Council Ref: DA115/18  
Your Ref: SSD 17\_8669  
KRR (CIS)

13 June 2018

**RE: REDEVELOPMENT OF ST ALOYSIUS COLLEGE (CONCEPT AND STAGE 1)**

Figure 1 – Extract from Height of Building Map in NSLEP 2013

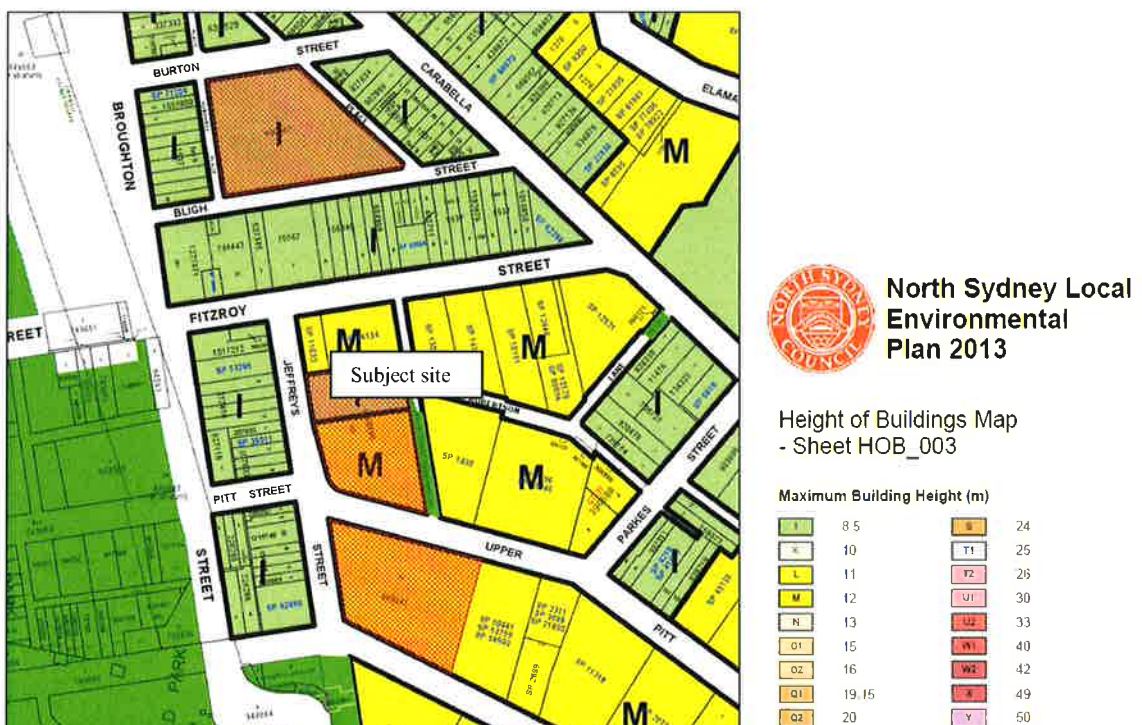
Clause 4.3(3) of NSLEP 2013 states that the maximum permitted building height on the site is 12 meters or 8.5 metres depending of the location of the respective campus and applicable height controls (refer to Figures 1 below).

The height control lines have not been plotted upon the elevation and section plans as submitted and accordingly it is difficult to gauge the full extent of existing breaches to the Building Height control and impacts associated with new elements in breach of the control.

Council is of the view that the scale of the new additions particularly the new infill building located close to the eastern boundary site are incompatible with density of the locality. Whilst from a design standpoint, the location of the additions is appropriate, from a density standpoint, the additions infill what little remaining airspace remains between two five storey built forms. Existing buildings on adjoining sites the east and south generally exhibit building heights of 3-4 storey. Buildings to the west of the site are generally 2-3 storeys in height and accordingly the building as existing already displays densities far above that typical of the immediate locality.
